REPORT NO. 4

I hereby certify that this Preliminary Drainage Report for Ryder Truck was prepared by me (or under my direct supervision) in accordance with the provisions of the City of Aurora Storm Drainage Criteria Manual for the owners thereof.

**INLET IN A SUMP OR SAG LOCATION**

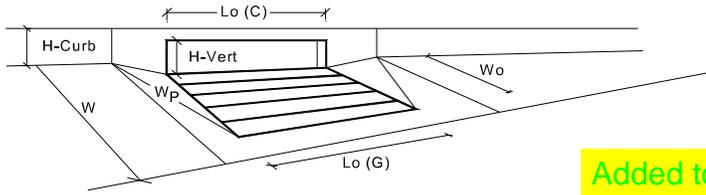
Remove and include in Final Drainage Report

Added to the FDR

**CROSS SECTION OF GOPHER GULCH, U.S. OF POND GG02:**  
FROM APPROVED MASTER DRAINAGE REPORT BY MARTIN MARTIN ENGINEERS: PORTEOS - HARVEST ROAD AND 56TH AVENUE, DATED JANUARY, 2012 AURORA ID# 212052MD1

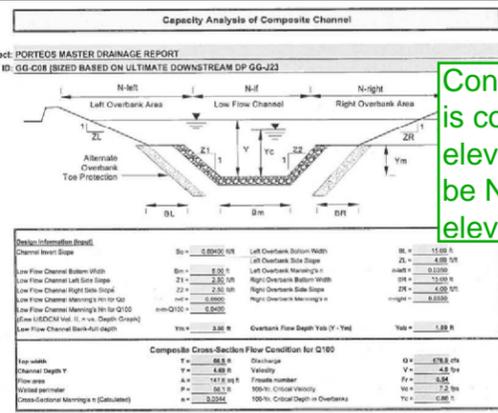
Confirm this elevation / ID from note above is correct. Both have similar desc., but elevations are 50 ft off. Elevation needs to be NAVD 88, nclude NAVD 88 after elevation

Remove from this sheet.

Using COA BM

Benchmark has been changed

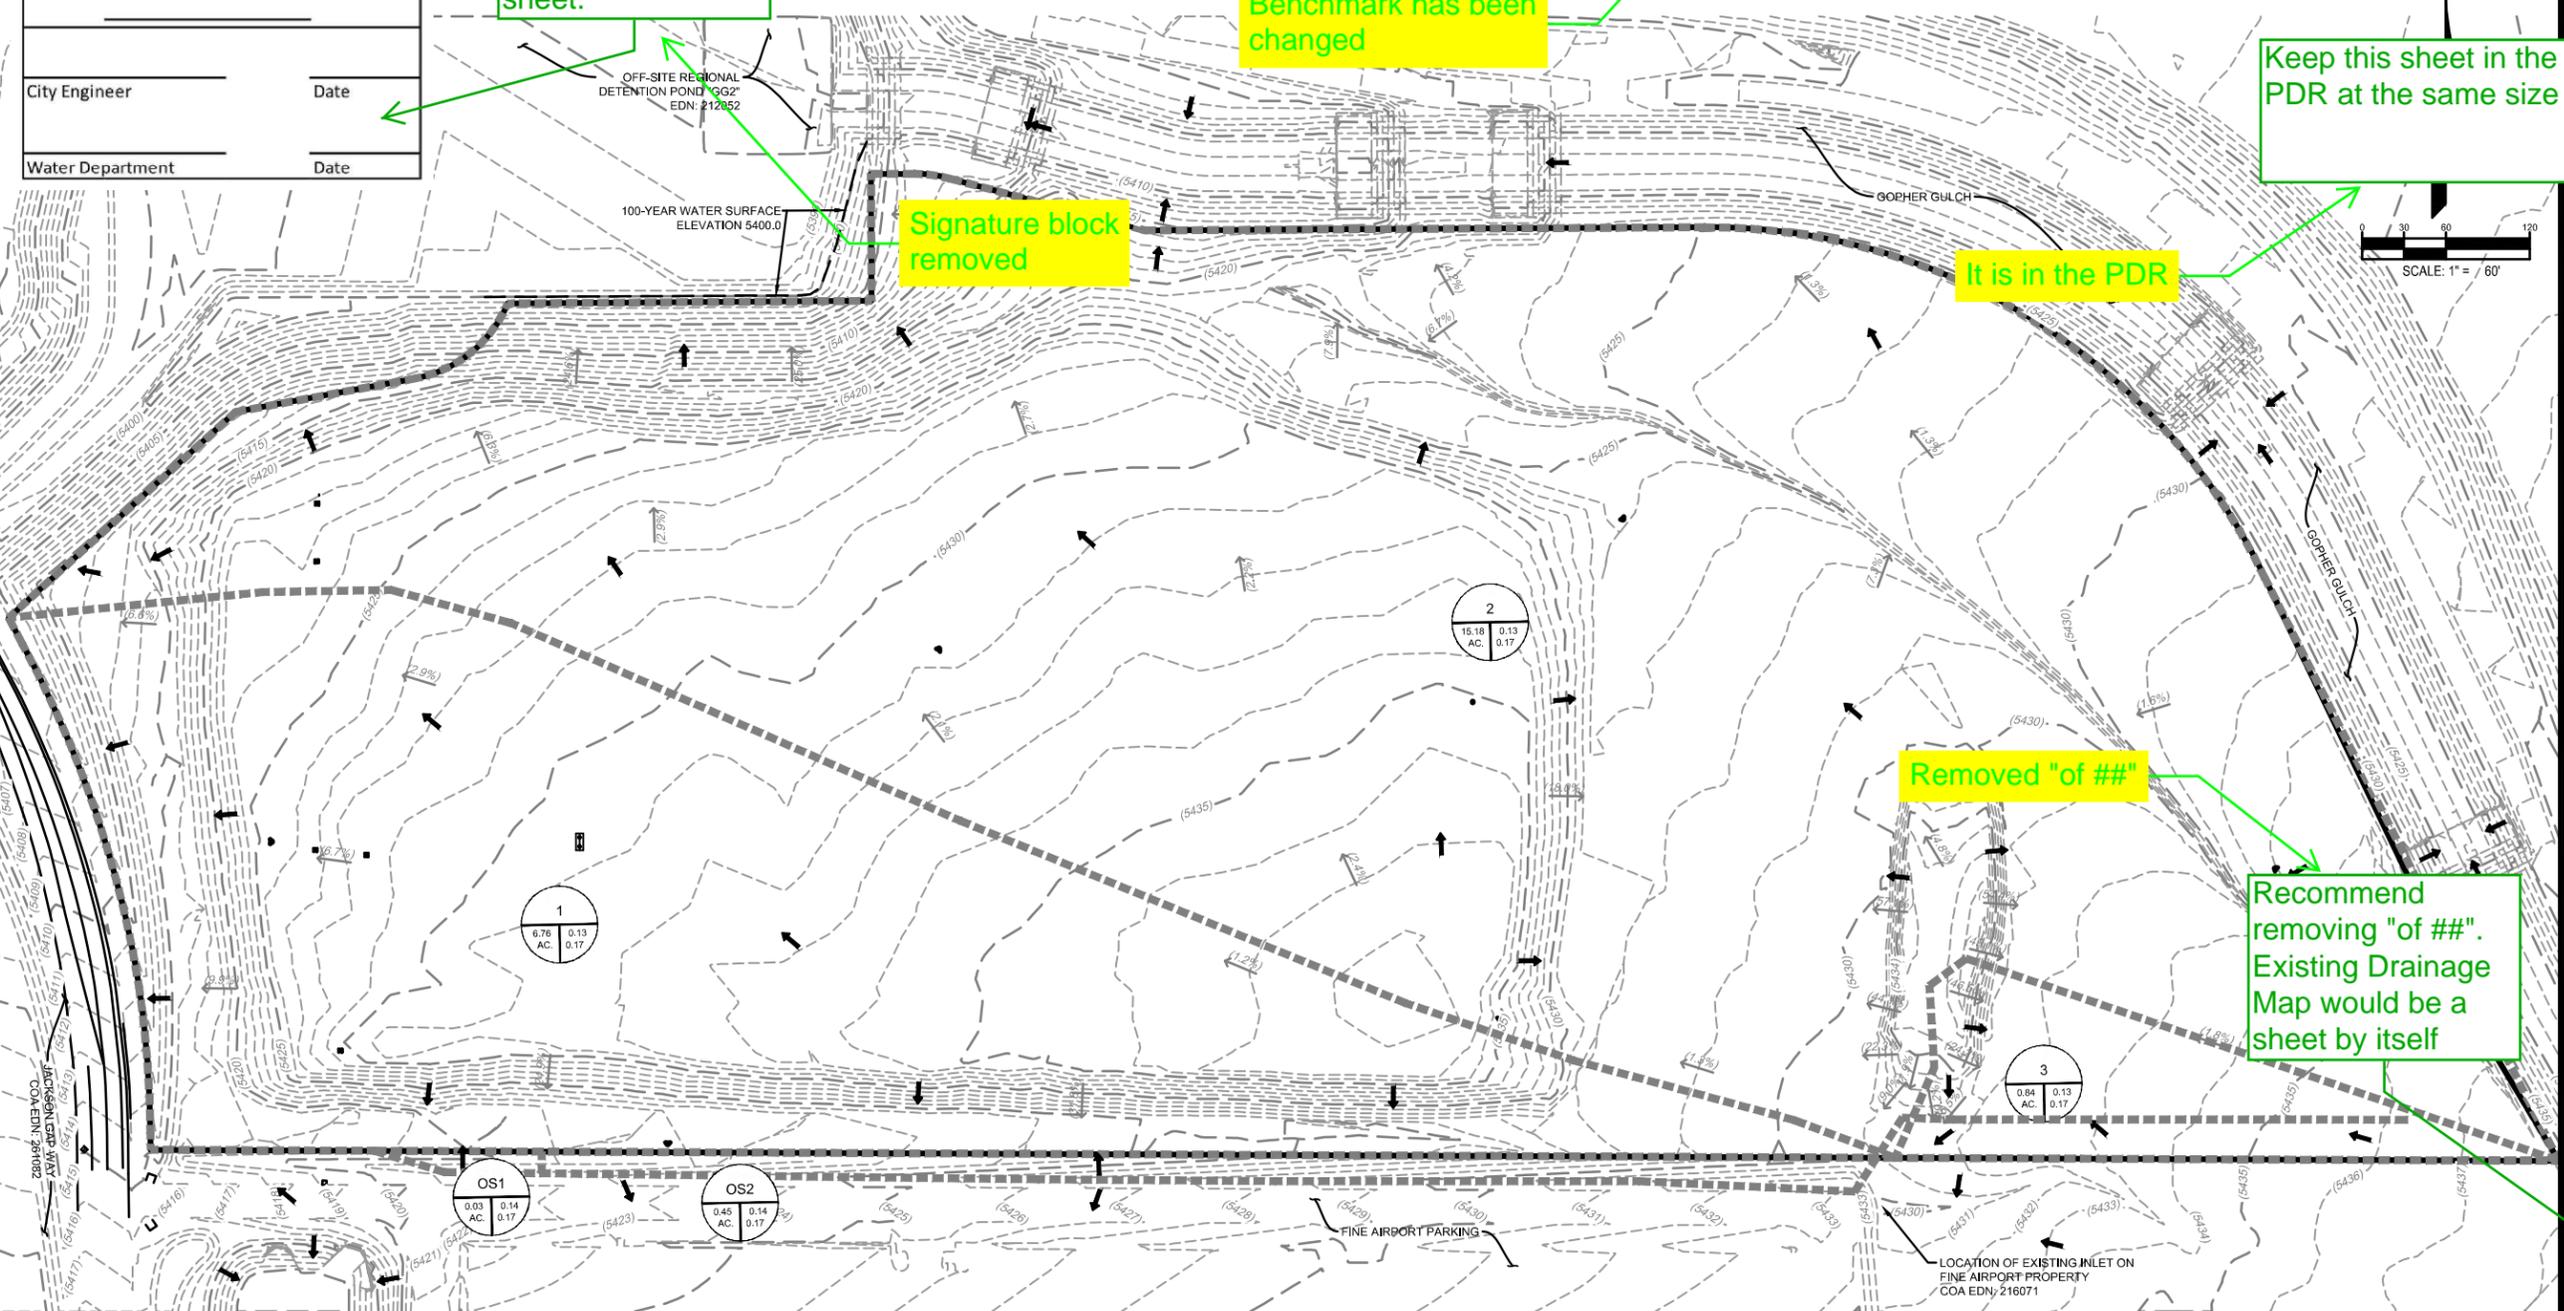
Keep this sheet in the PDR at the same size

Recommend removing "of ##". Existing Drainage Map would be a sheet by itself

It is in the PDR

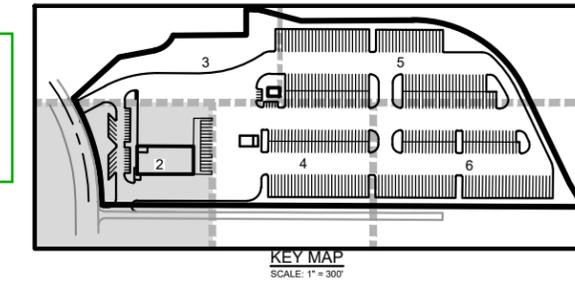
**Advisory Note:** FDR will need to include analysis from Jackson Gap showing HGL / storm capacity in addition to street capacity already provided. Can utilize design from Fine Point offsite design report.

Provide turning radius for Drainage Easement access.

Previous Comment Minimum 0.5% for concrete, 2% for other impervious, 5% for pervious for first 10 ft away from building per 2.08.1.06 and 2.08.1.06.2. Show slopes on plan

Provide a ROW dimension

Portion of this sidewalk is on private property. A letter from property owner will be needed acknowledging the improvements and allowing access. Will be required on first Civil Plan Submittal

Remove this sheet from the PDR and place in a separate file set, DO NOT include Civil Plans. Size sheet to be 22x34 or 24x36. If there is confusion with this please reach out to jcoleman@auroragov.org

Show road classification per 2.06.03 & 4.04.2

Include Signature block in the lower right corner on this sheet only

This will be Sheet 1 in the Drainage Plan submittal. Recommend removing "of ##"

Added COA BM

Turning radius added

Added slope arrows

Added collector

Signature block added

**RYDER TRUCK**  
 DETAILED GRADING PLAN

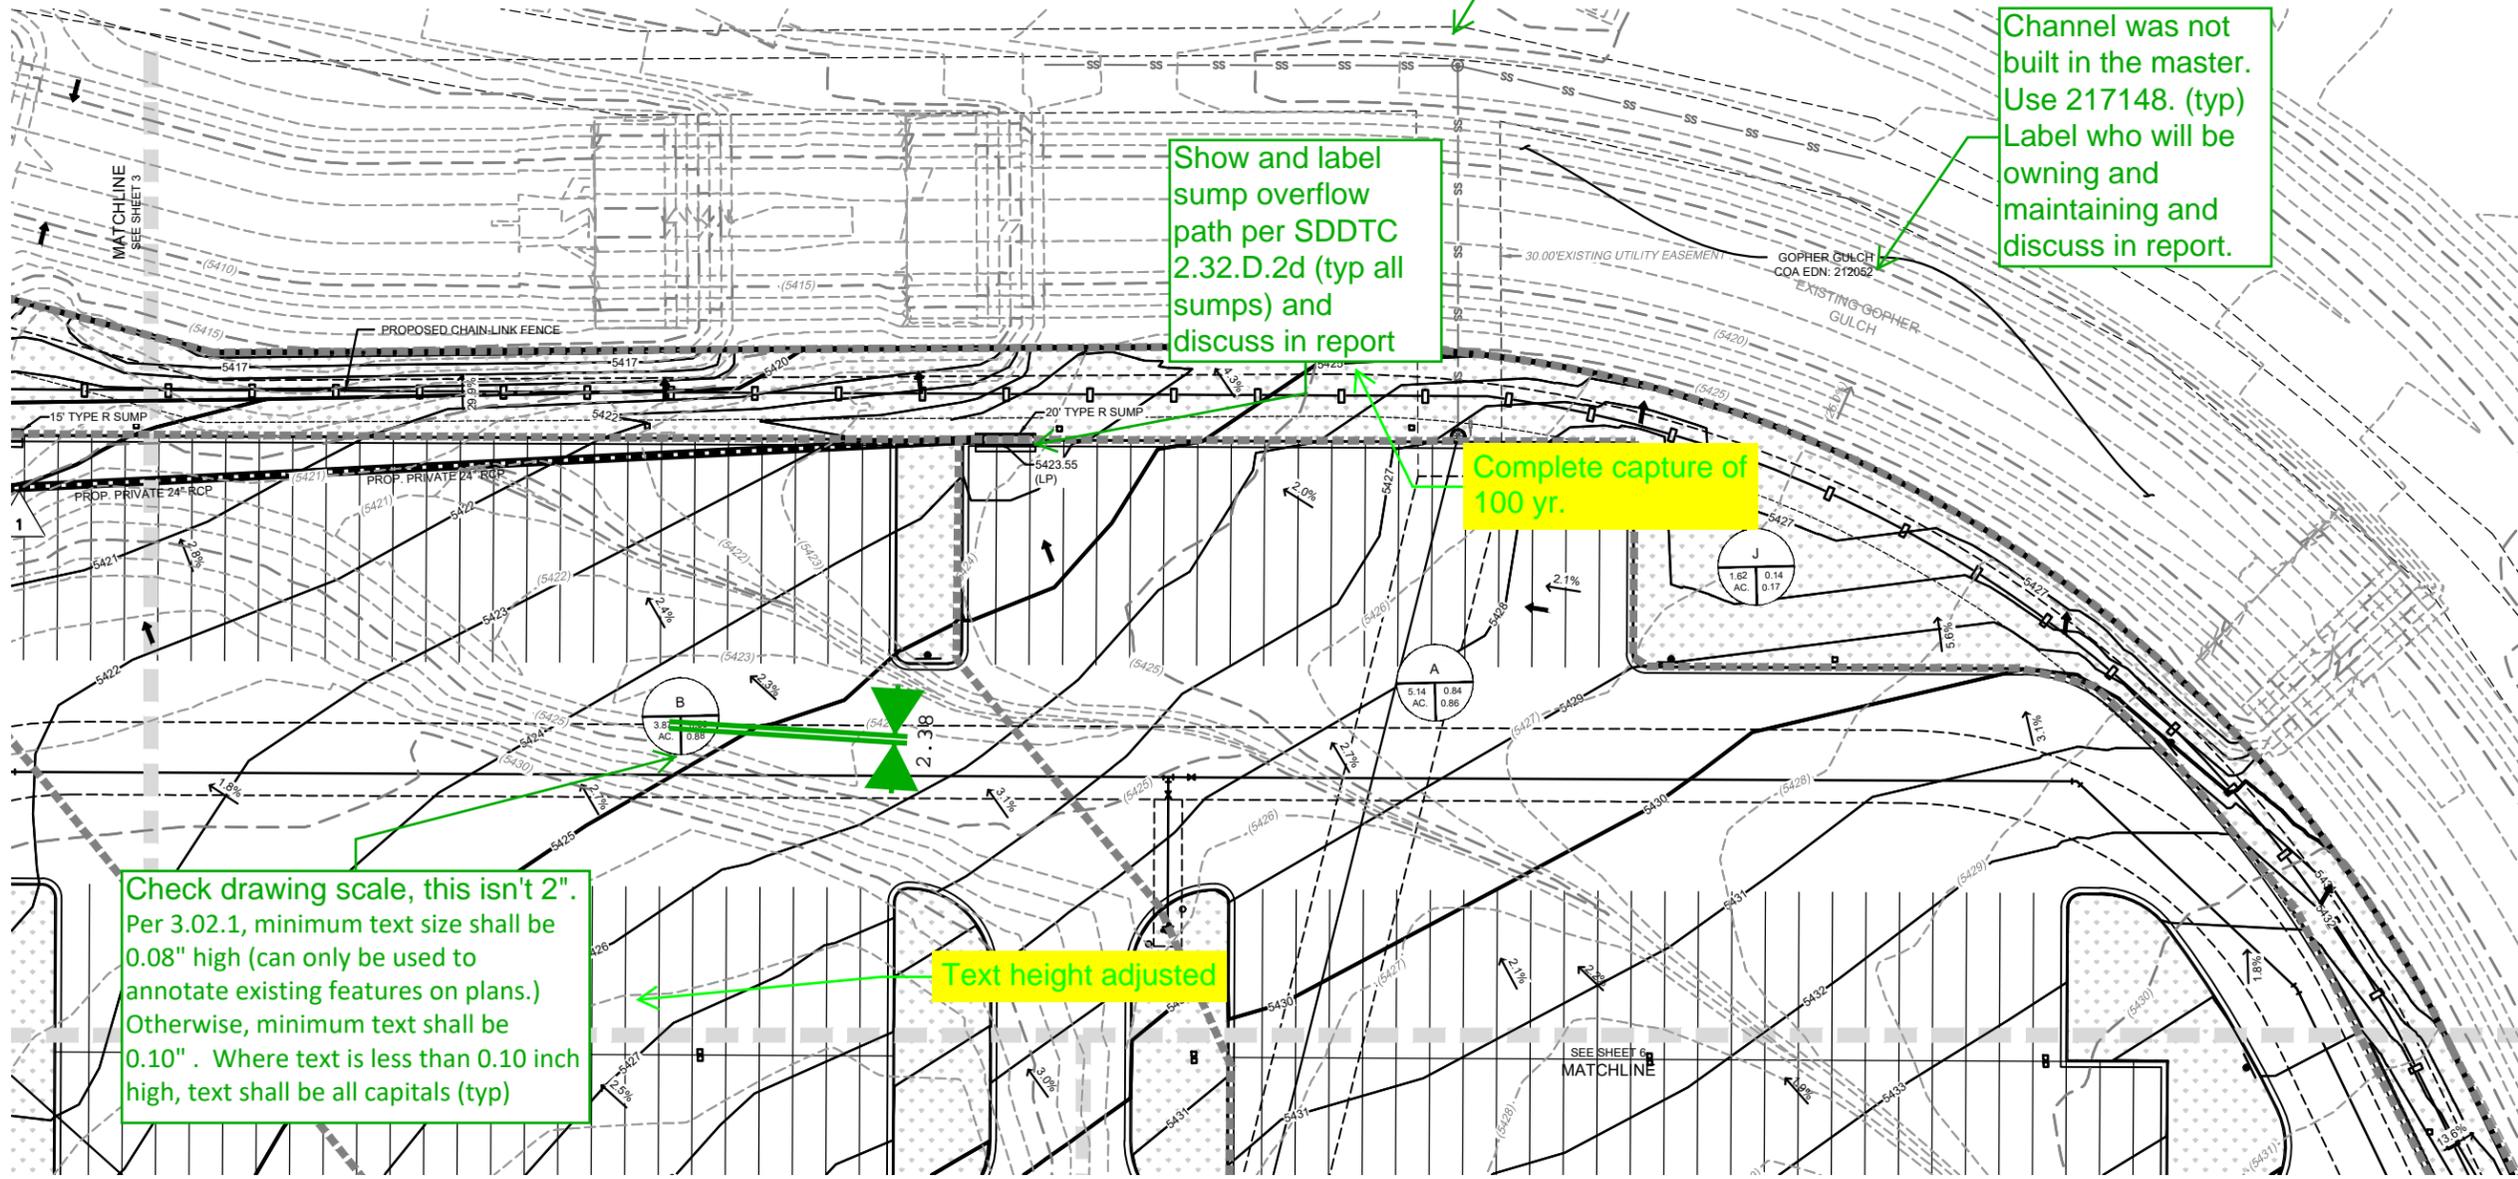
Show and label sump overflow path per SDDTC 2.32.D.2d (typ all sumps) and discuss in report

Channel was not built in the master. Use 217148. (typ) Label who will be owning and maintaining and discuss in report.

Check drawing scale, this isn't 2". Per 3.02.1, minimum text size shall be 0.08" high (can only be used to annotate existing features on plans.) Otherwise, minimum text shall be 0.10" . Where text is less than 0.10 inch high, text shall be all capitals (typ)
